Application No. 10/083,760
Amendment dated June 8, 2004
Reply to Office Action dated April 27, 2004

Amendments to the Drawings:

Fig.2

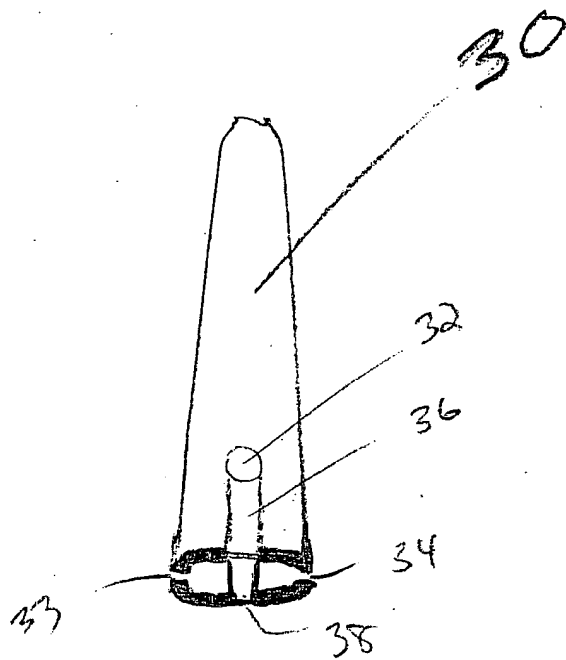
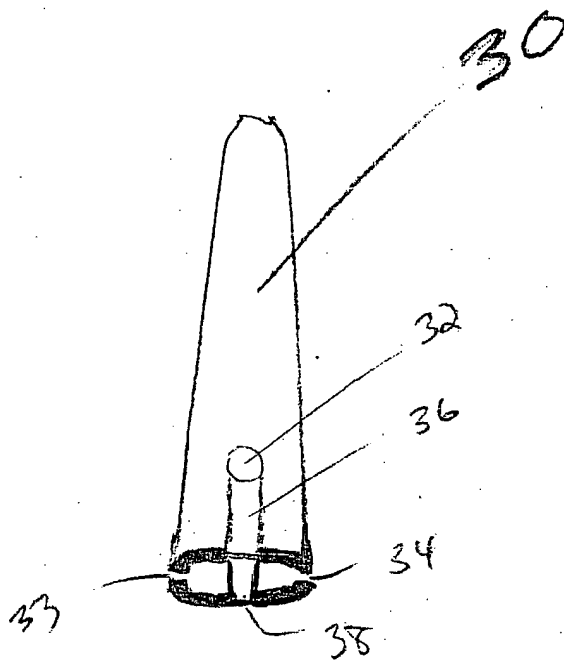
The attached sheet of drawings includes changes to Figs. 2 and 4, which appear on drawing sheets 2 and 4 respectively. These sheets 2 and 4 replace the original sheets 2 and 4. In Fig. 2, the element 38 has been completely shown. In Fig. 4, the element identifier "22" has been added.

In paragraph 2 of the Office Action, the Examiner has objected to the drawings under 37 CFR 1.83(a) because the rivet head channel is not shown in the drawings.

Upon review of Fig. 2, rivet back channel 38, although partially illustrated, is not shown in full. Rivet back channel 38 as described on page 6, paragraph [0015] of the specification, is similar to rivet head channel 36 except that it is located on the back side of cover 30.

As shown in Fig. 2, the reduced thickness at the open end of cover 30 is shown for rivet head channel 38, but the rest of the channel extending up towards the closed end of cover 30 was inadvertently not shown. As such, Applicant has amended Fig. 2 to show rivet back channel 38 extending away from the open end of cover 30 towards the closed end of cover 30, until it disappears behind the top of cover 30. This amendment Fig. 2 more clearly illustrates the element as described and more closely corresponds to the other rendition of rivet back channel 38 shown in Fig. 4.

In view of the foregoing, Applicant respectfully submits that the Amended Fig. 2 properly shows all of the described and claimed elements and requests that the objection to the drawings be withdrawn. Applicant further notes that pages 5 and 6 of the specification adequately support the drawings amendments, and that no new matter has

Fig. 4

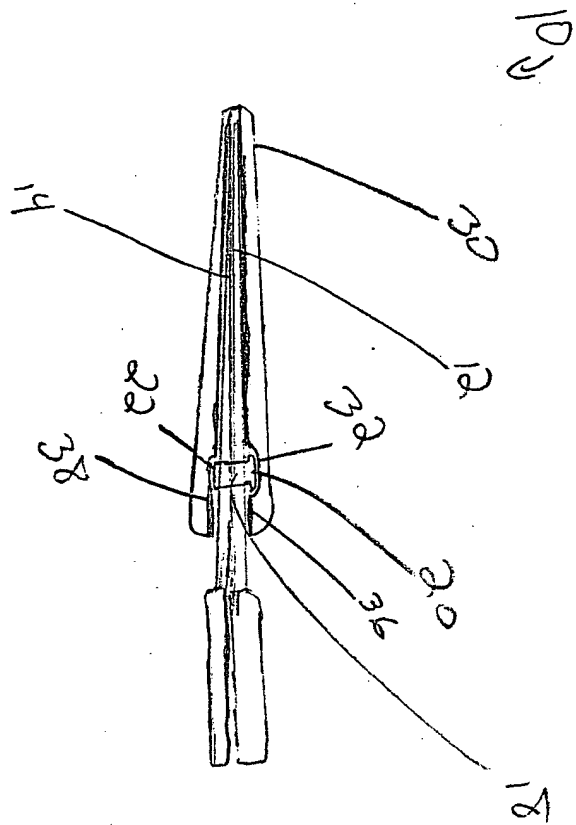
In paragraph 1 of the Office Action, the Examiner has objected to the specification because the element identifier "22", on page 5 is missing from the drawings. Applicant has amended paragraph [0011] of the specification to indicate that element 22 is illustrated in Fig. 4, and the corresponding element identifier "22" has been added to Fig. 4. As such, Applicant respectfully requests that the objection to the specification be withdrawn.
